MIL-C-17587B(SH)
AMENDMENT 3
4 March 1994
SUPERSEDING
AMENDMENT 2
29 April 1987

MILITARY SPECIFICATION

CIRCUIT BREAKERS, LOW VOLTAGE, ELECTRIC POWER, AIR,
OPEN FRAME, REMOVABLE CONSTRUCTION

FIGURE 1. Outline and mounting dimensions for circuit breaker type ACB-900R.

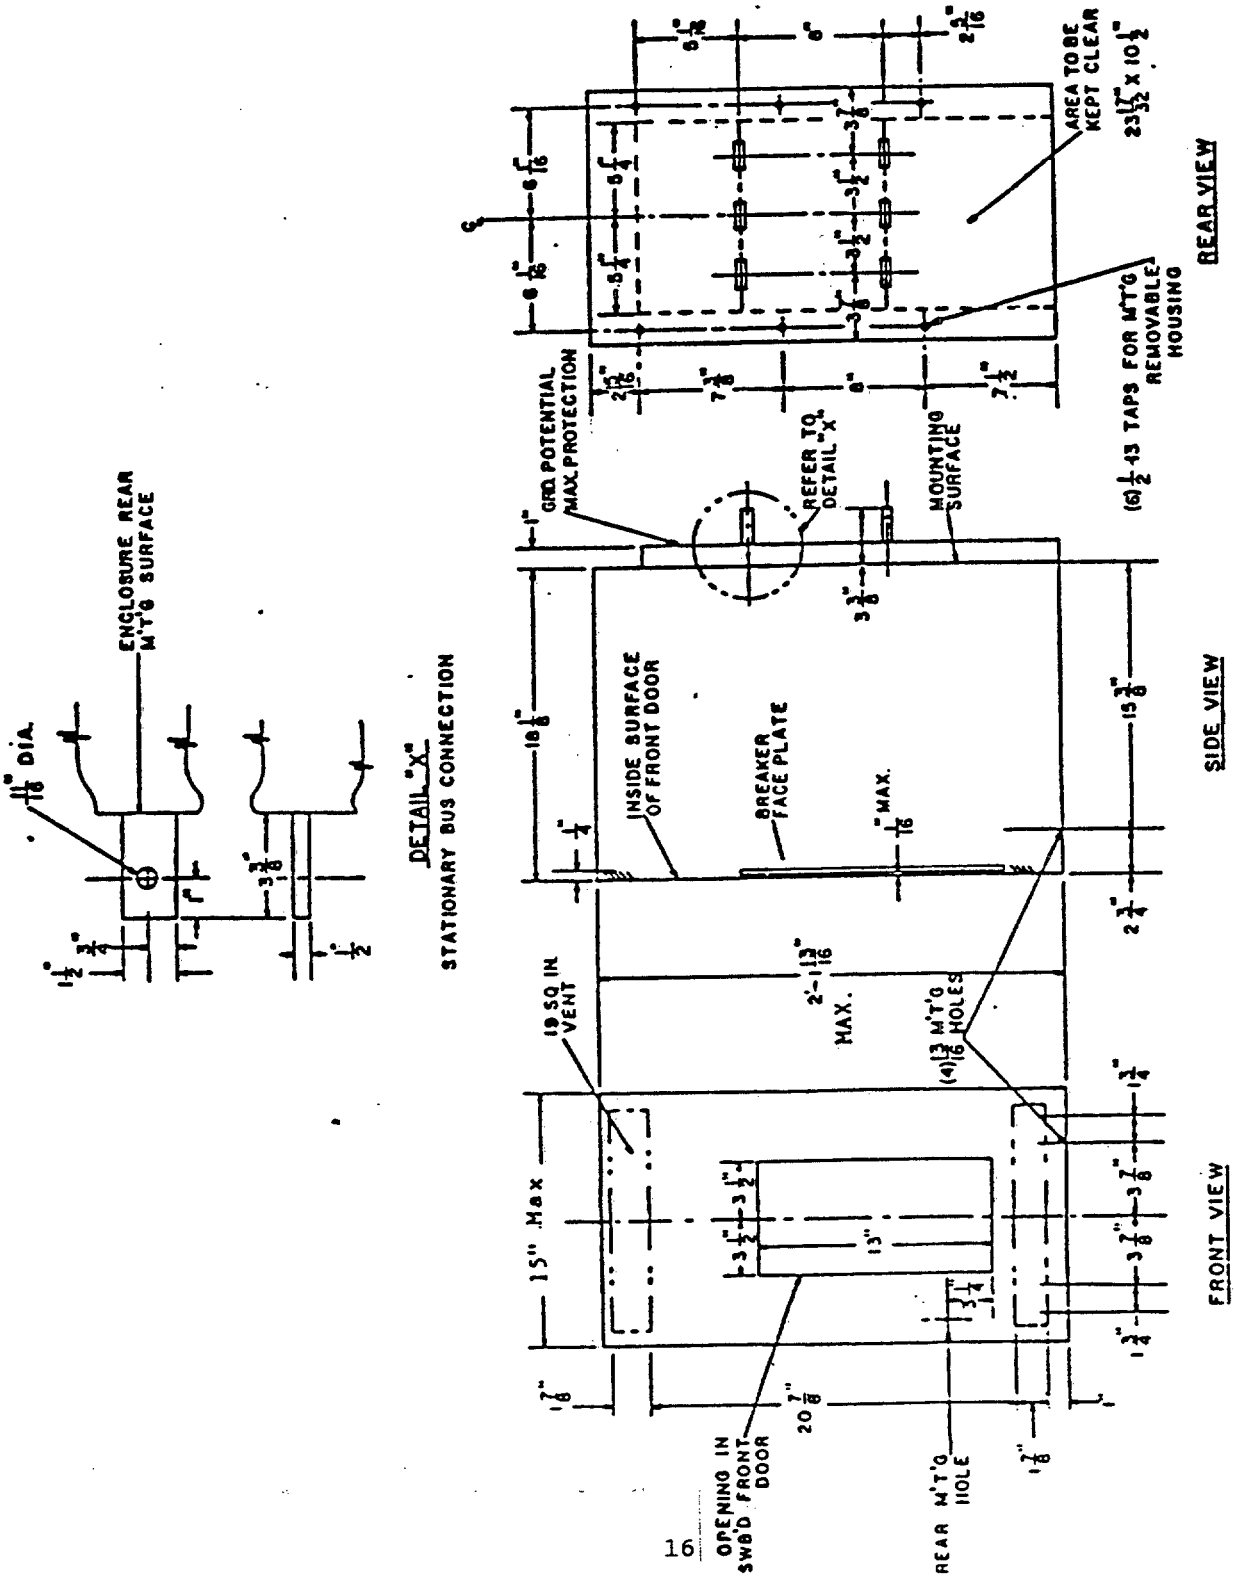
Figure 1: Delete and substitute:

FIGURE 2. Outline and mounting dimensions for circuit breaker type ACB-901R.

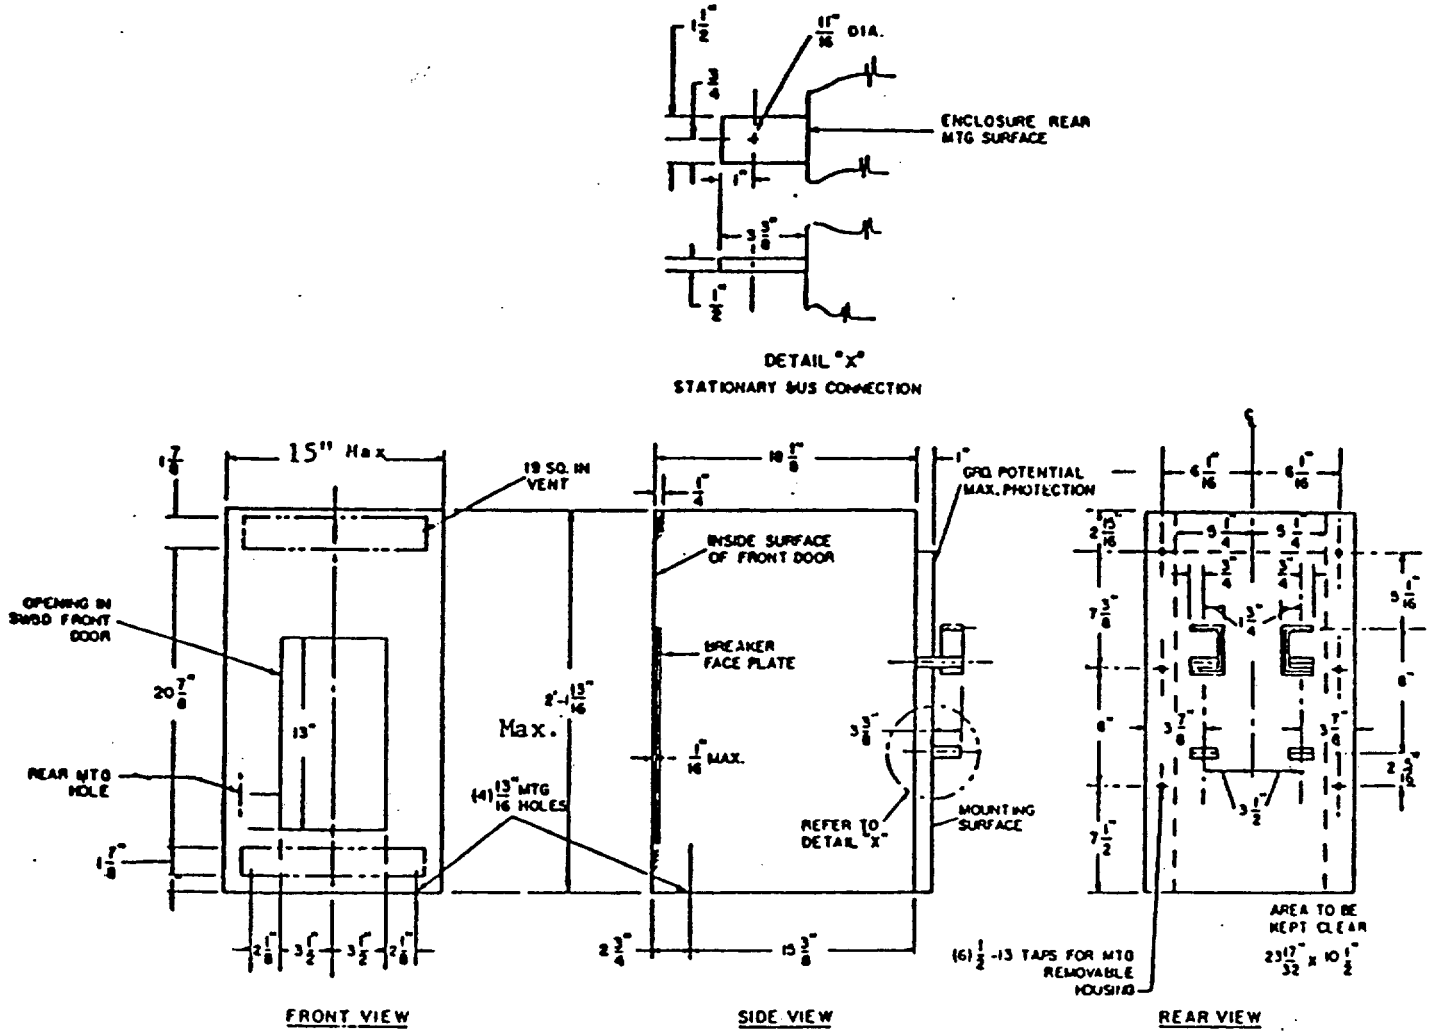
Figure 2: Delete and substitute:

FIGURE 4. Outline and mounting dimensions for circuit breaker types ACB-1600HR, ACB-2000R, ACB-2000LR, ACB-2601R, and ACB-2801R.

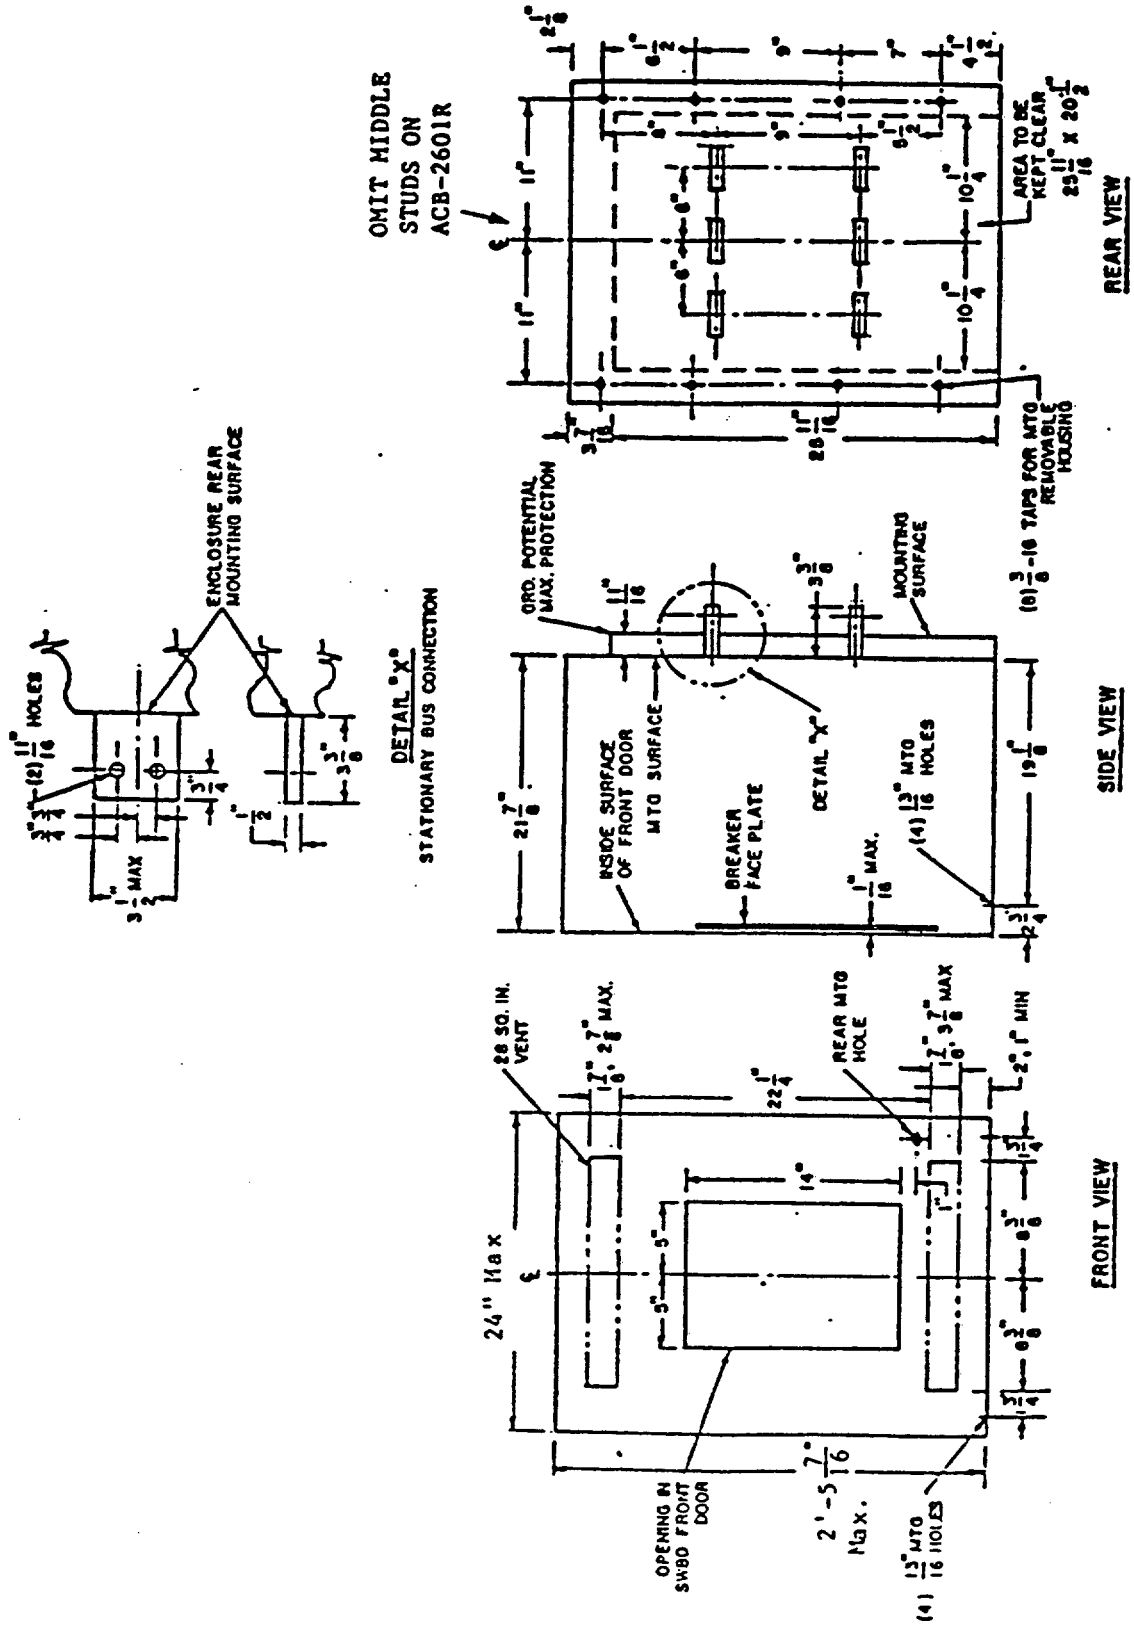
Figure 4: Delete and substitute:

FIGURE 5. Outline and mounting dimensions for circuit breaker type ACB-2002HR.

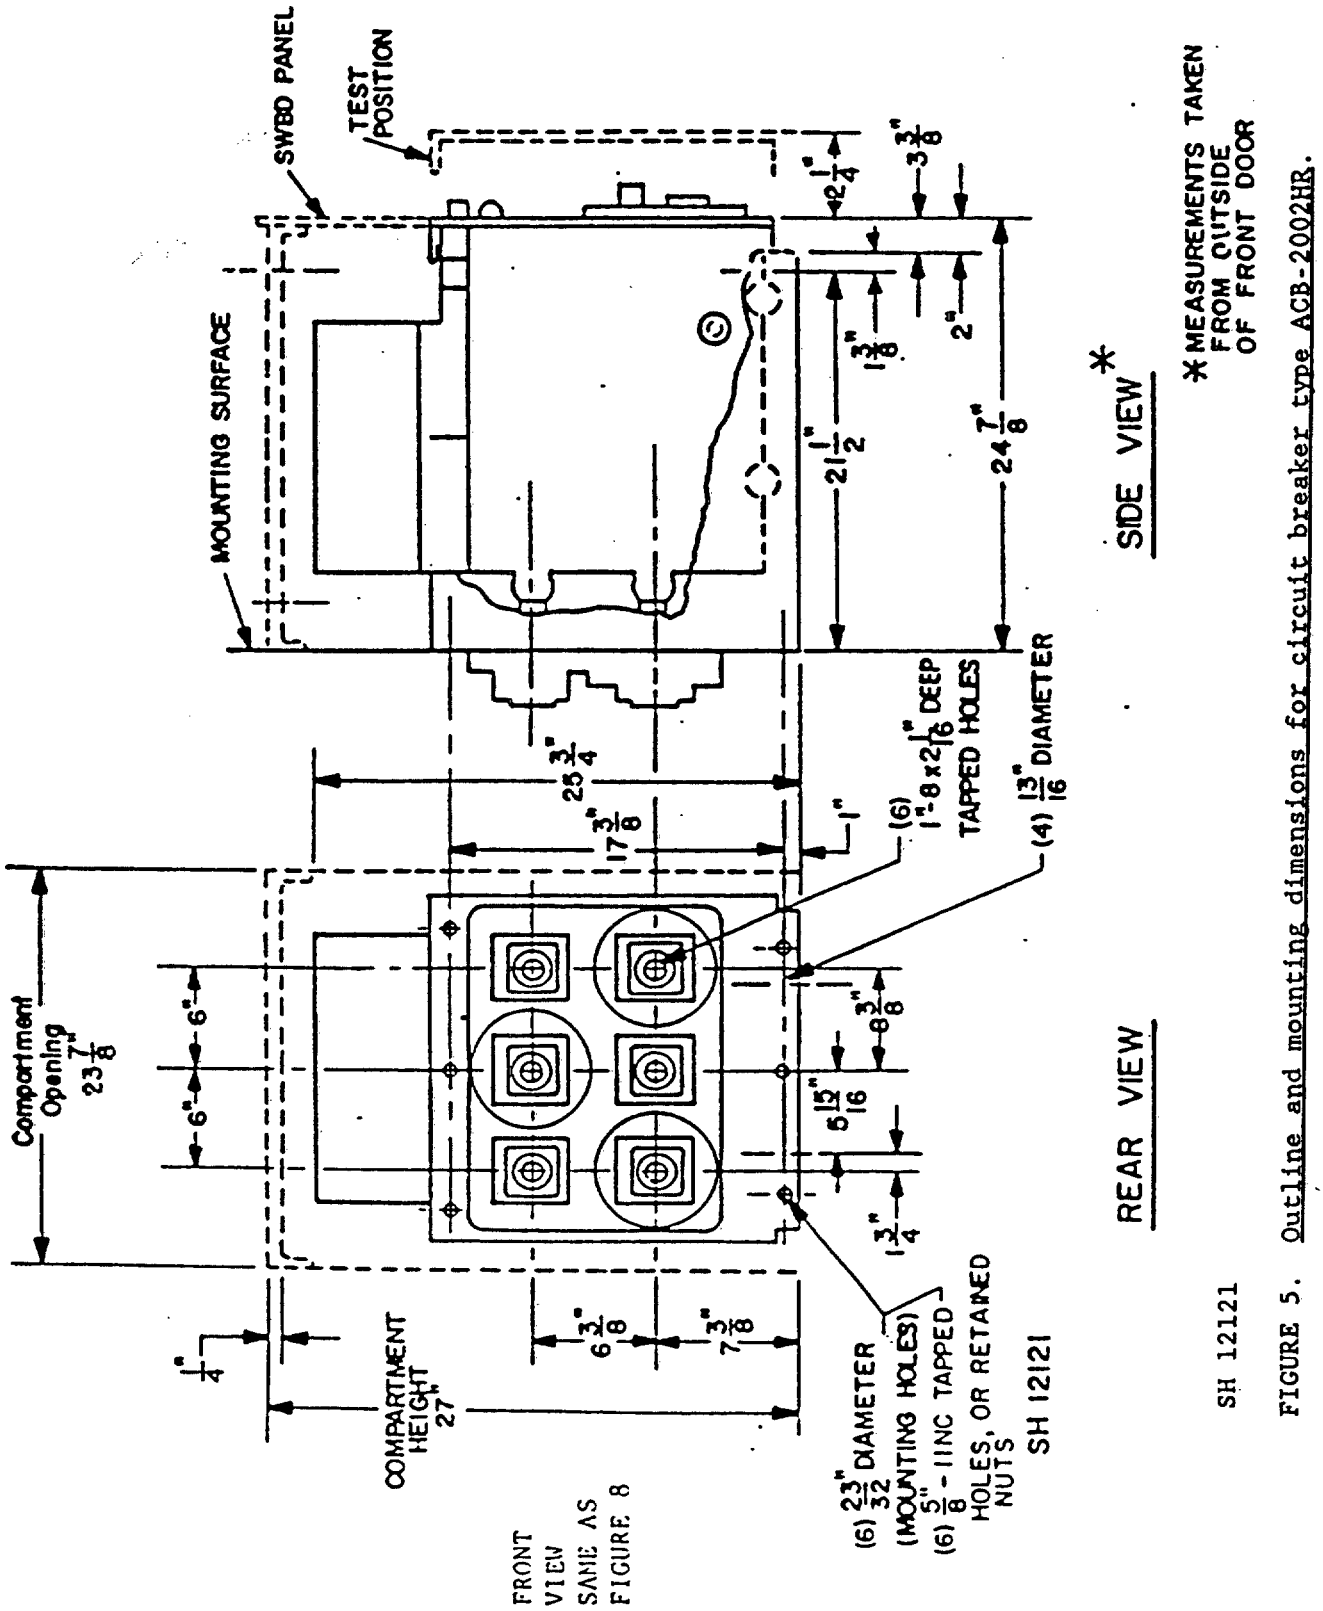
Figure 5: Delete and substitute:

FIGURE 7. Outline and mounting dimensions for circuit breaker types ACB-3200HR, ACB-4000HR and ACB-5001R.

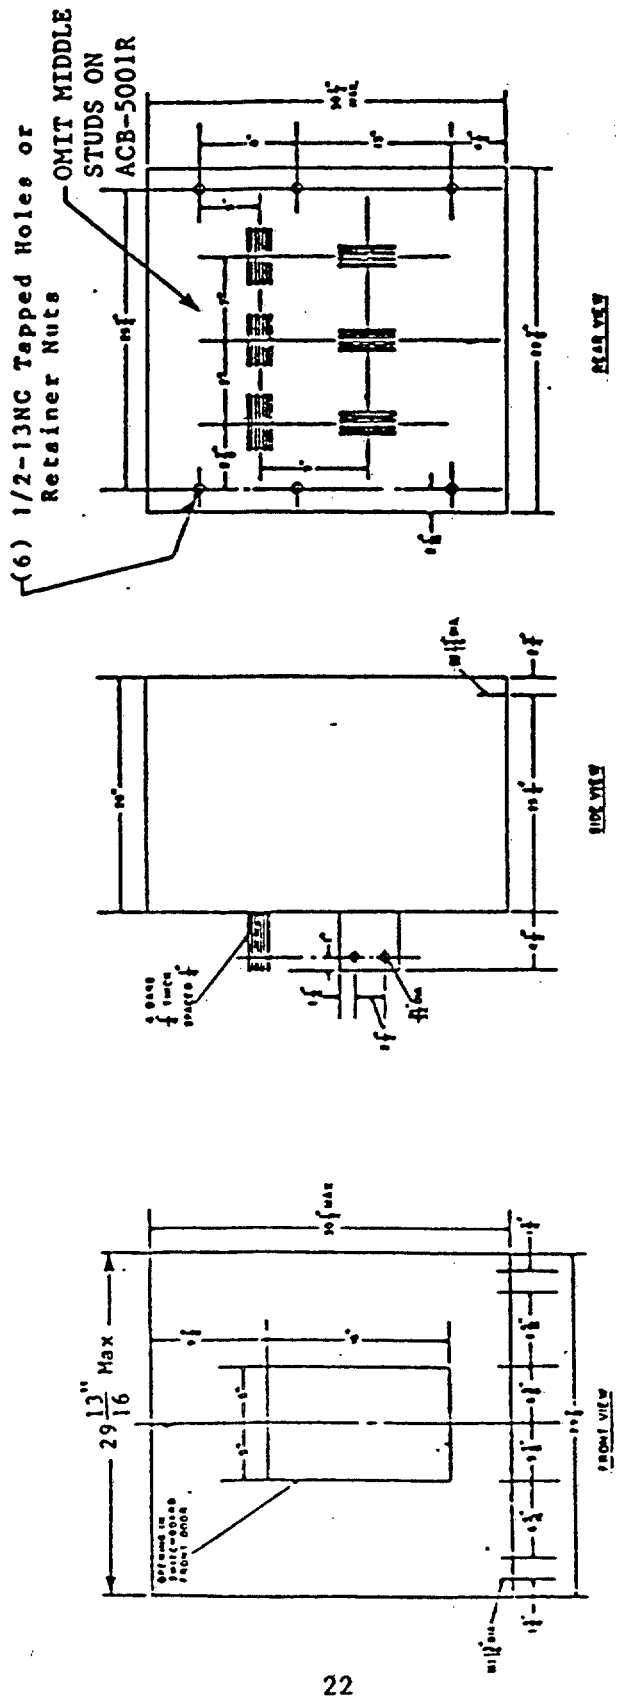
Figure 7: Delete and substitute:

FIGURE 8. Outline and mounting dimensions for circuit breaker type ACB-4001R.

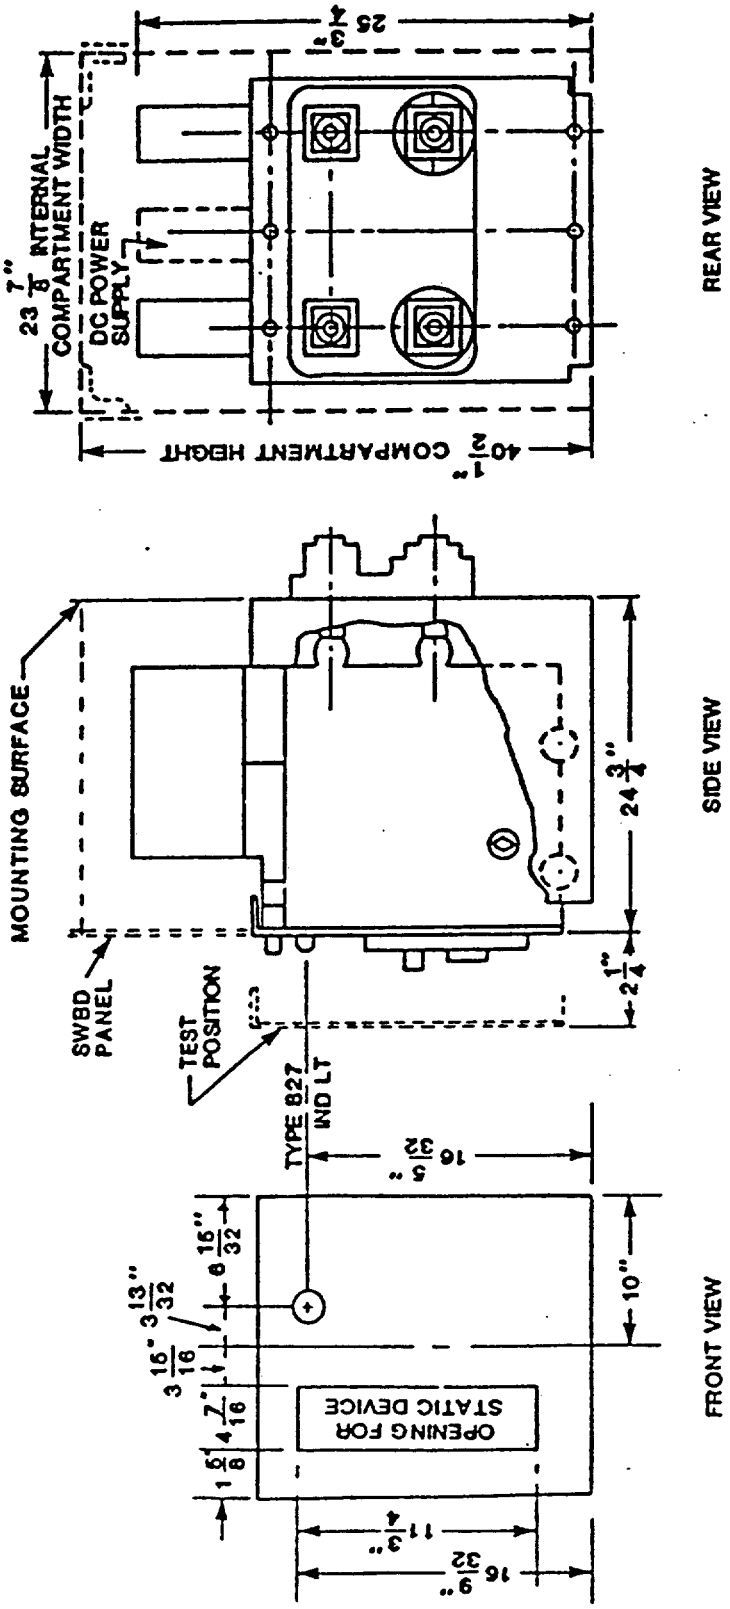
Figure 8: Delete and substitute:

FIGURE 9A. Outline and mounting dimensions for circuit breaker type ACB-1604LRG.

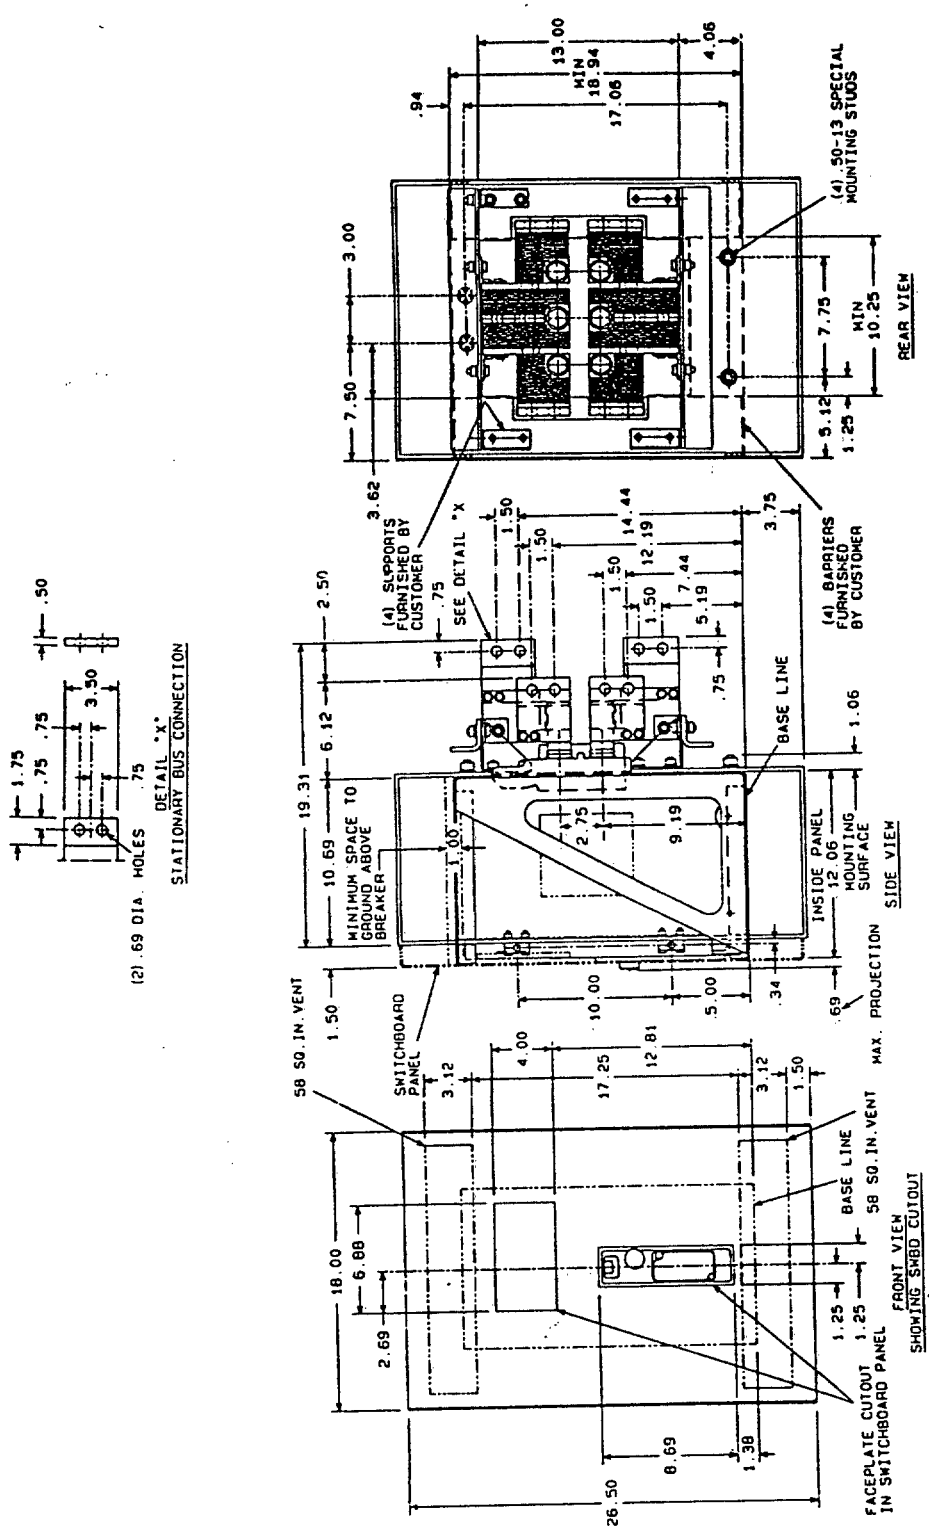
* Add new figure:
